ADDENDUM No. 1
to
Crook County Courthouse Electrical Upgrade
Request for Proposals

Date: March 15, 2023

The following changes, additions, and/or deletions are hereby made a part of the Request for Proposal Documents for the Courthouse Electrical Upgrade project in Crook County, Oregon dated February 28, 2023, as fully and completely as if the same were fully set forth herein.

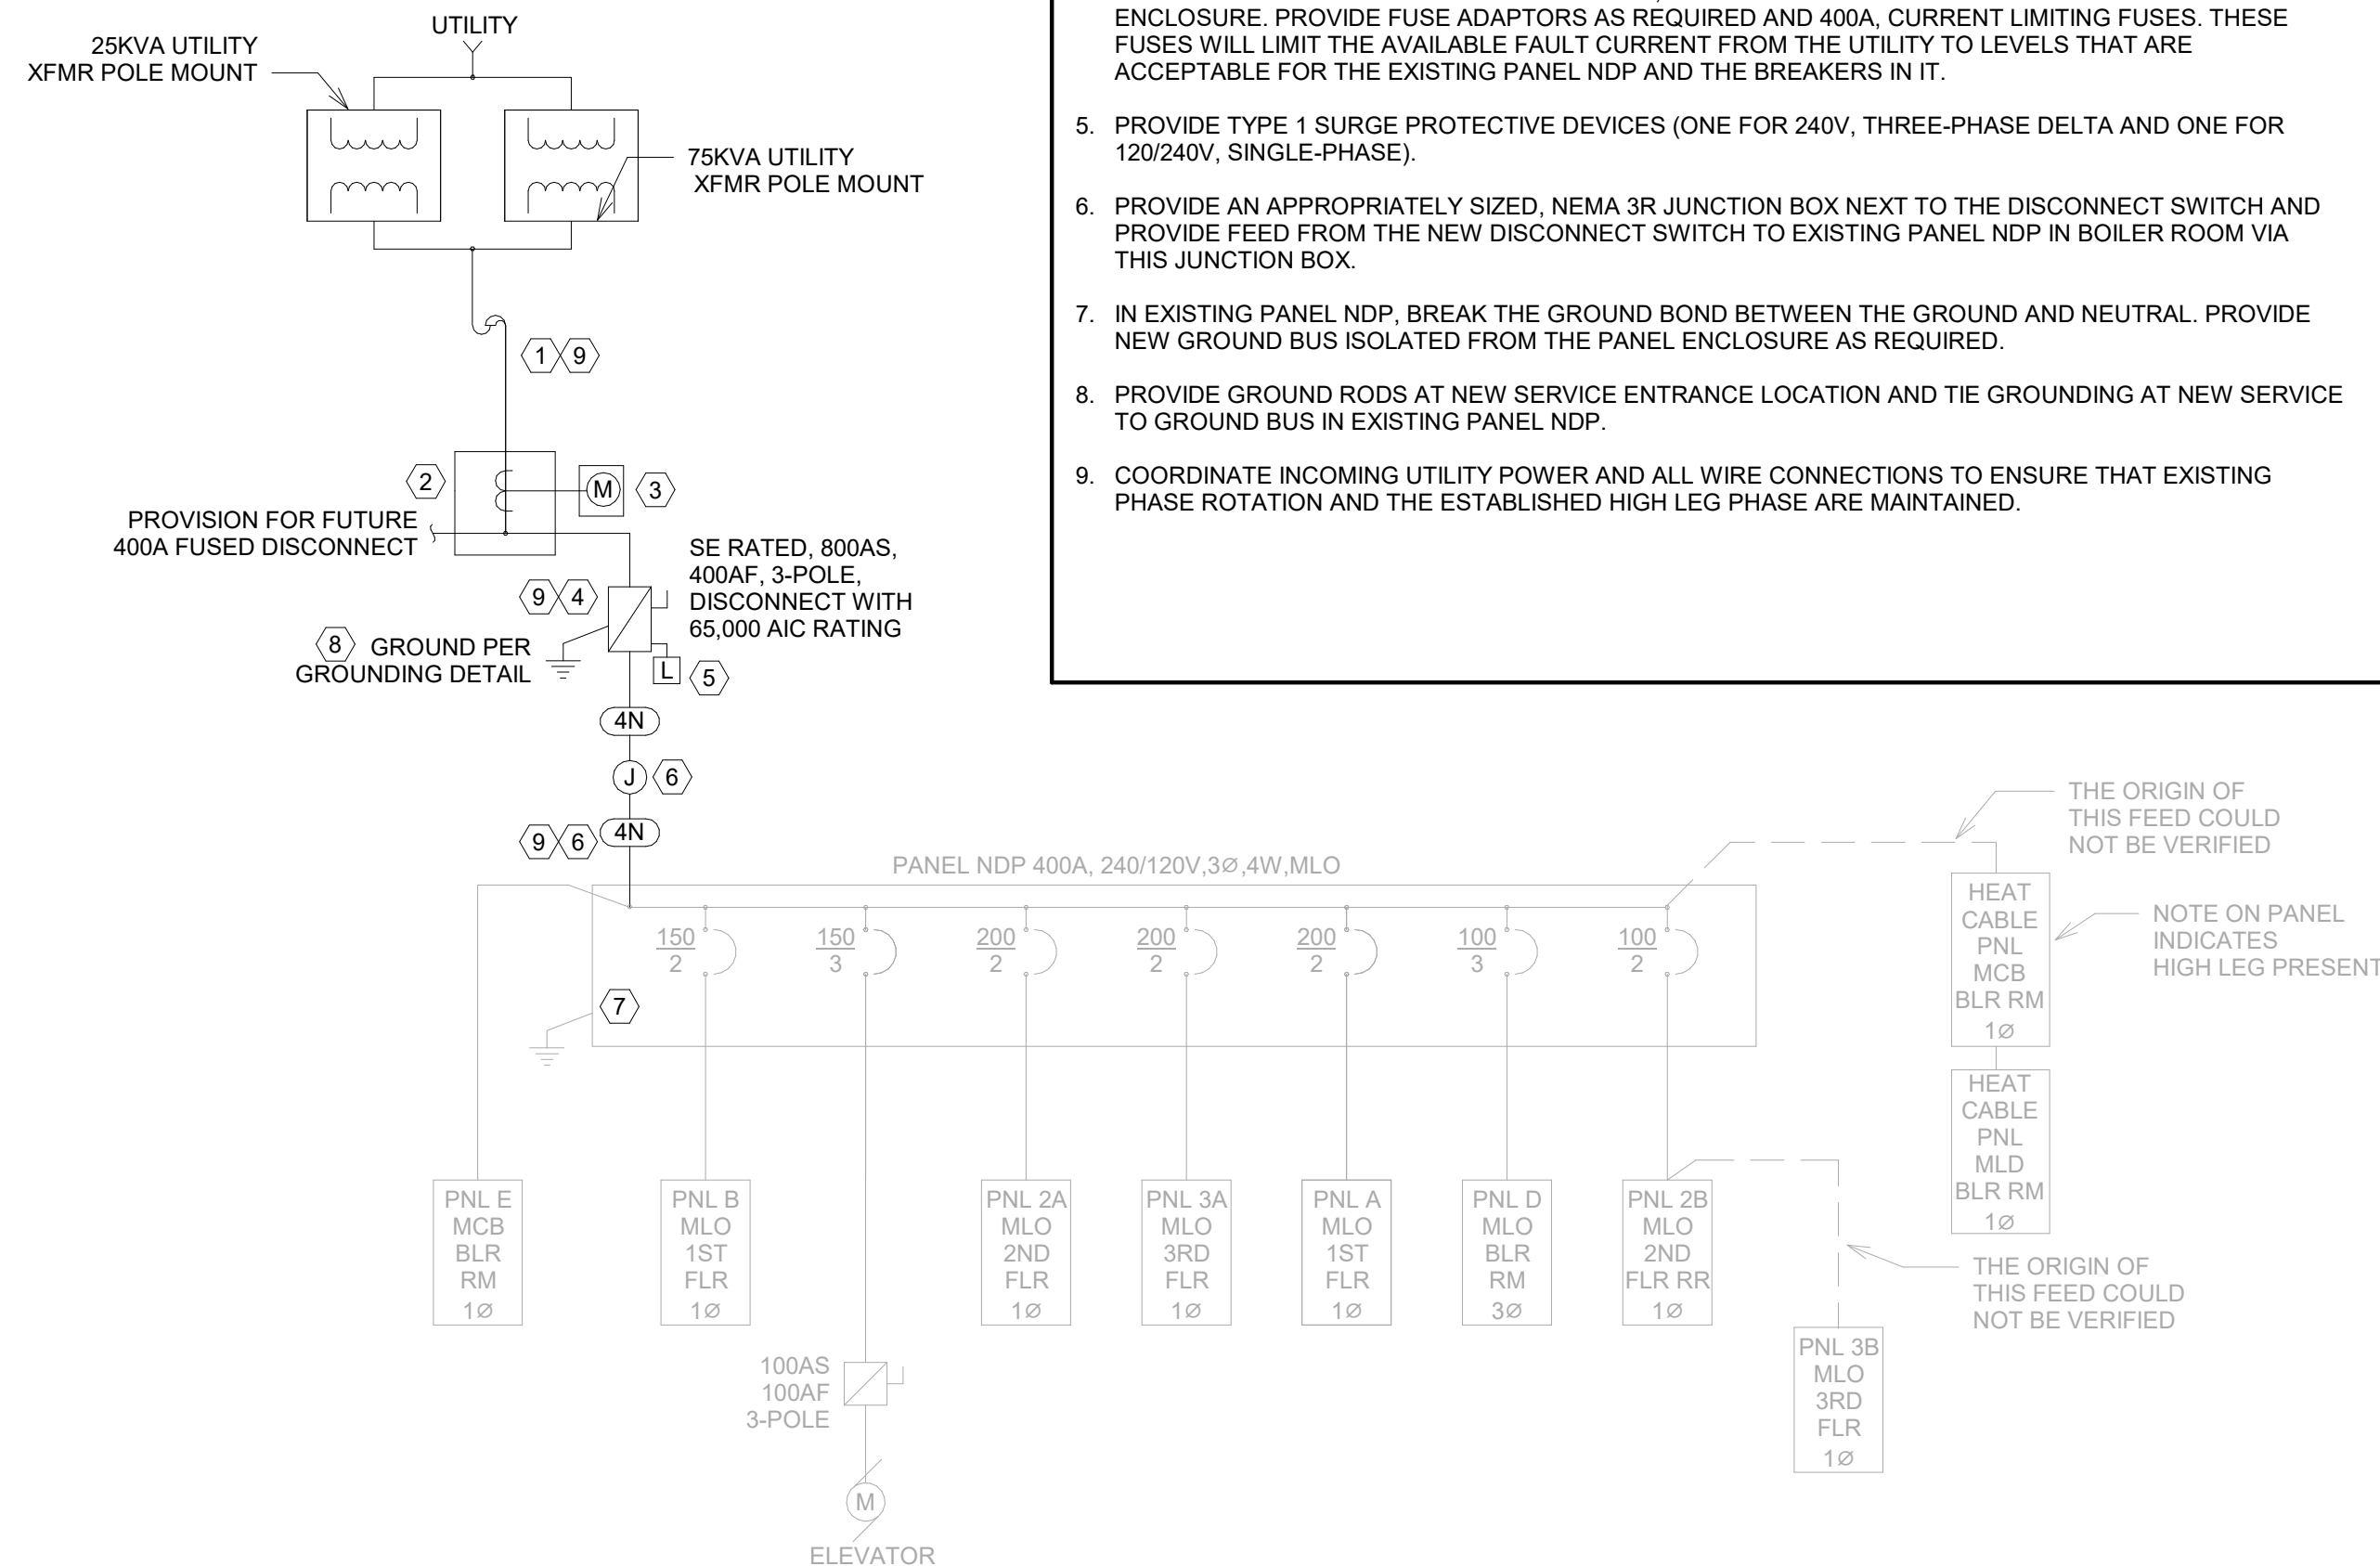
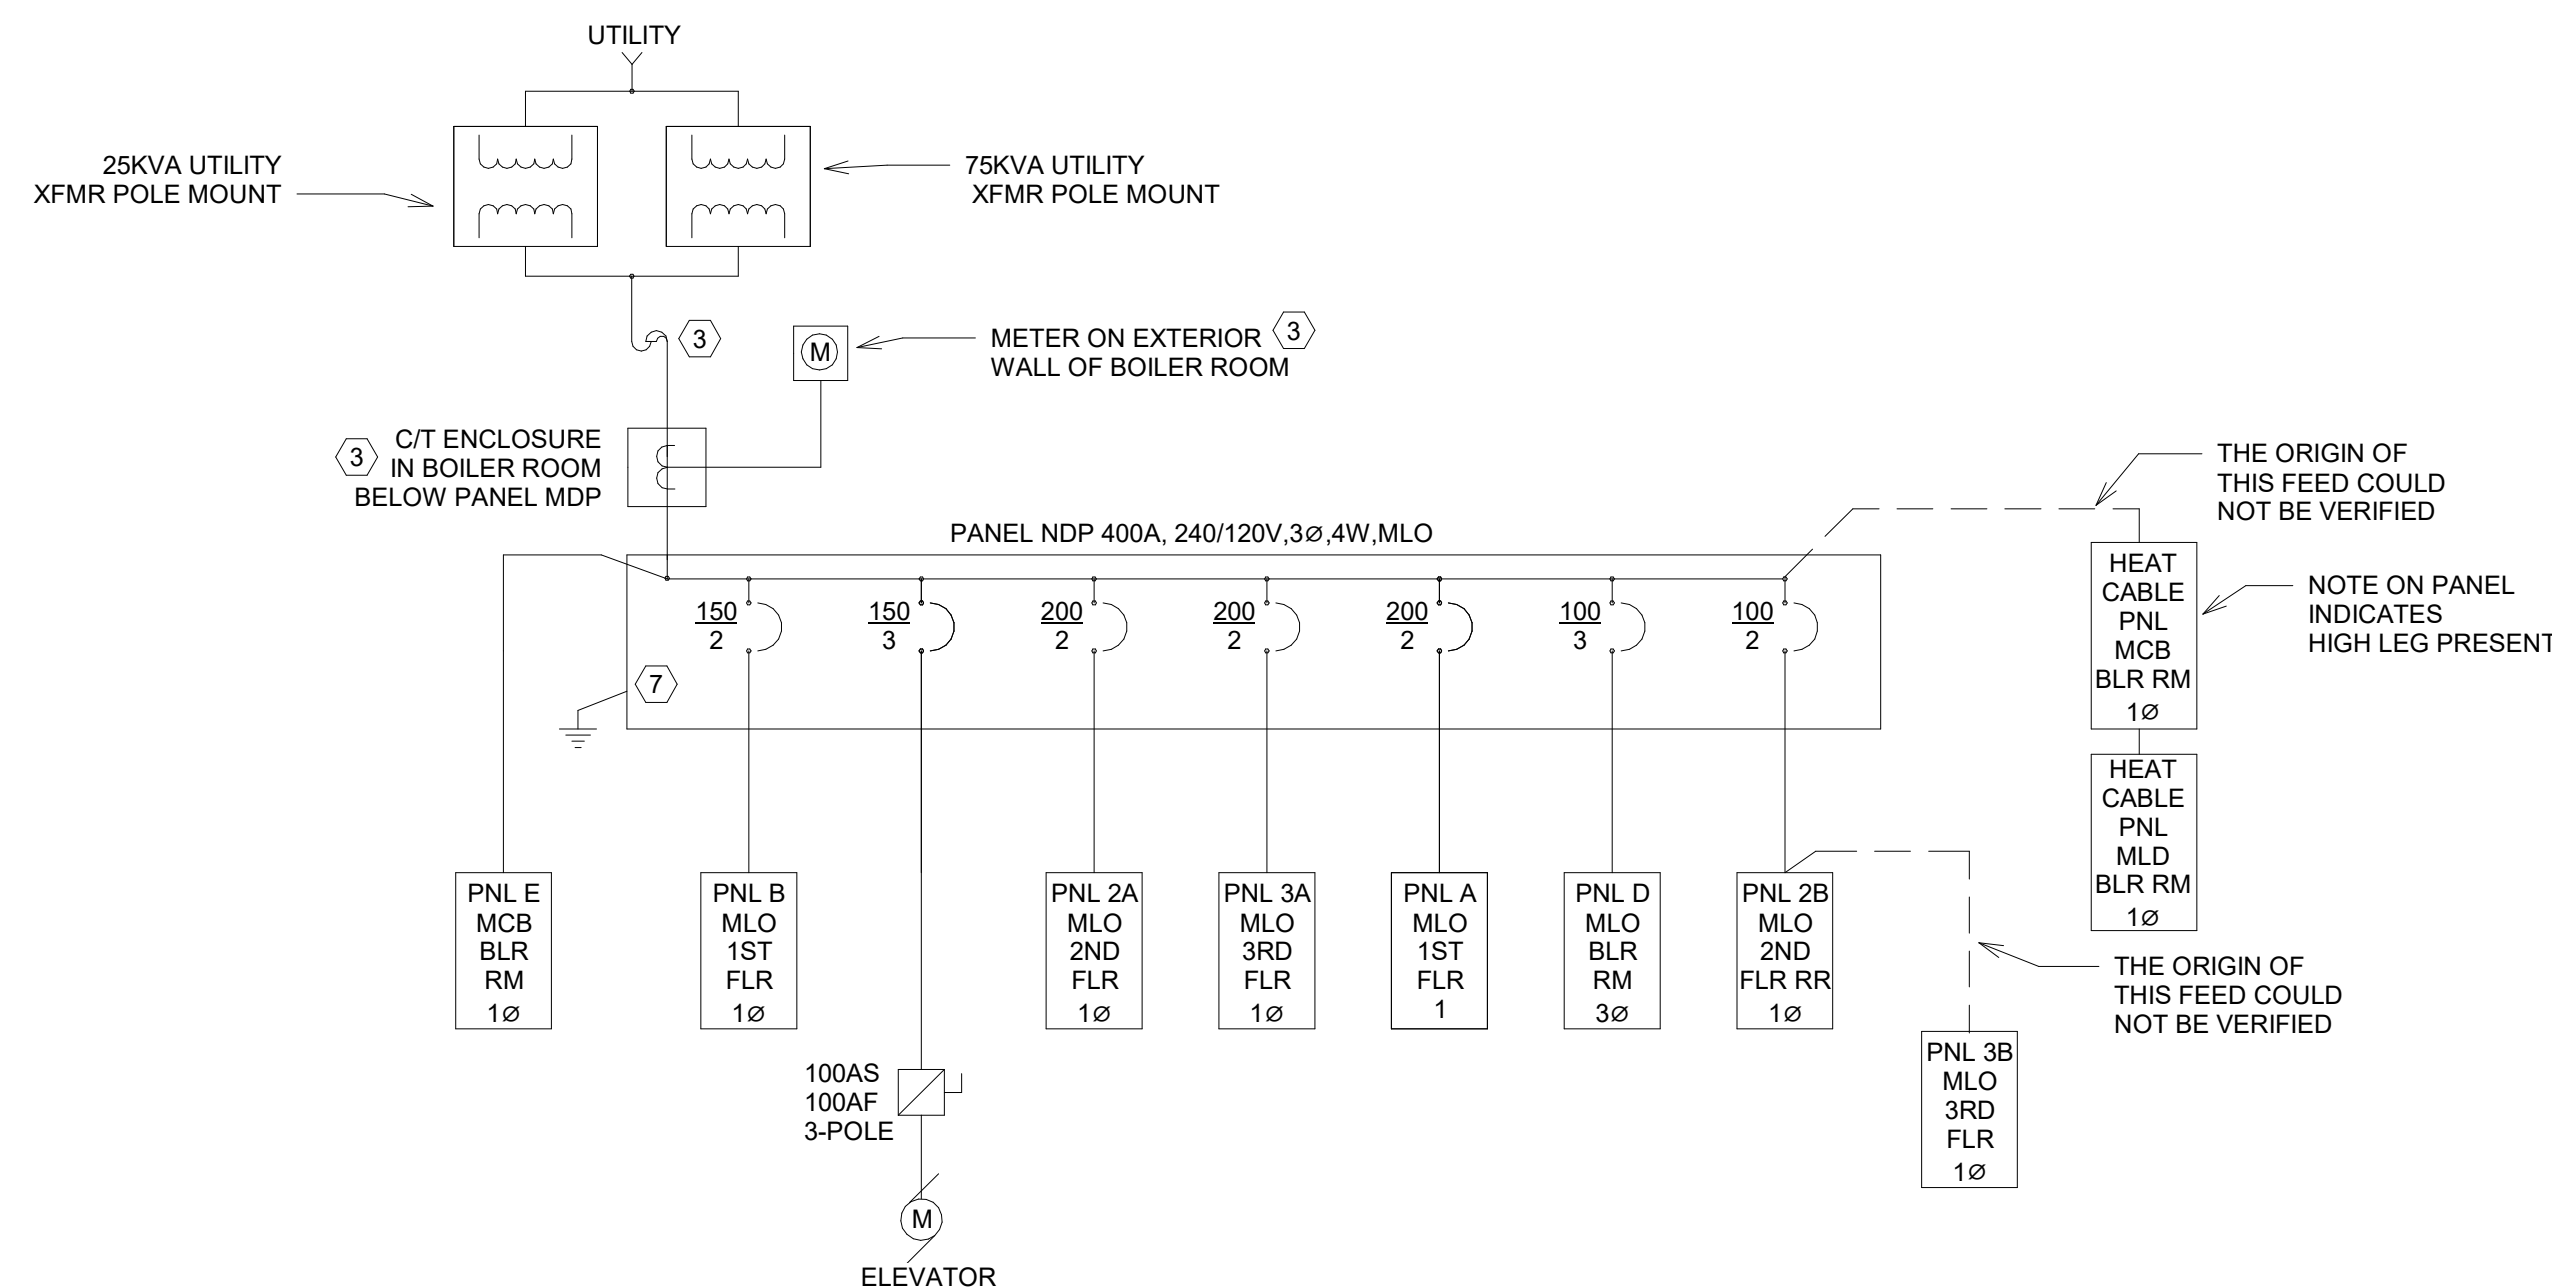
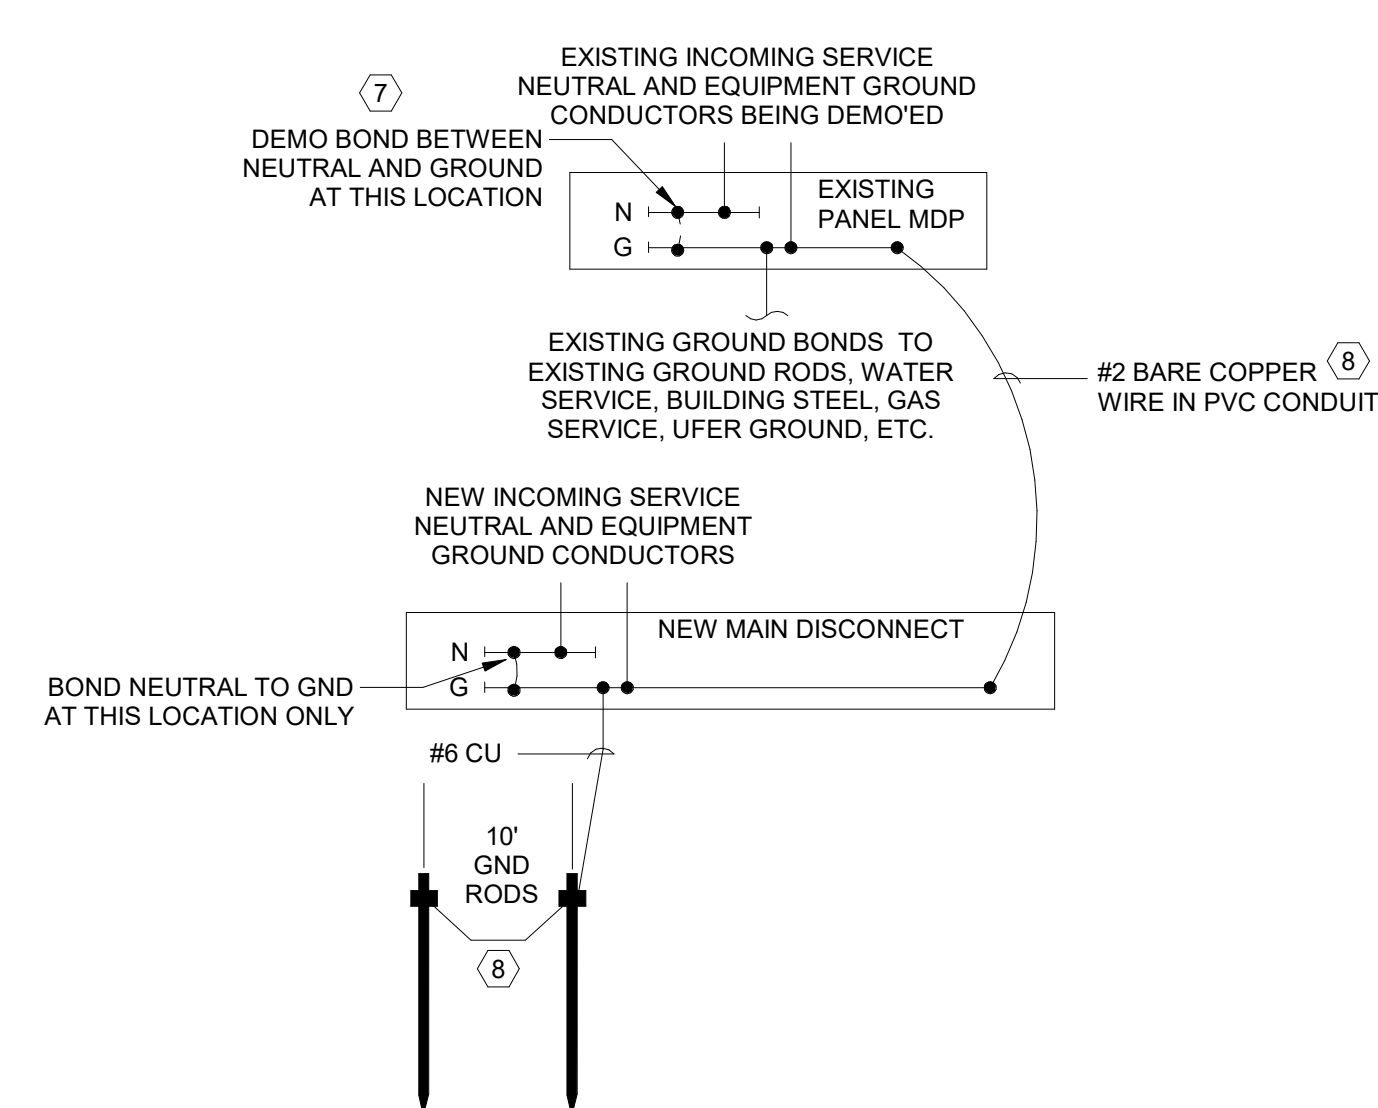
1. **Revised Sheet E-3** attached, note the following changes:
 - a. Instead of two options, there is now just one configuration for the service.
 - b. Key notes were changed to correspond with the revised service one line diagram.
 - c. The electrical service **will remain an overhead service**, but a new weatherhead will be installed to allow for modifications.
 - d. Relocation of the overhead service drop will need to be coordinated with the electrical utility.
 - e. An exterior junction box will be installed near the new disconnect switch and power will be routed through this to the existing Panel NDP.
2. Contractor to obtain permit. Crook County to reimburse for cost.
3. The existing ADA parking space located at the east side of the electrical/boiler room will be relocated to allow for installation of new electrical gear.
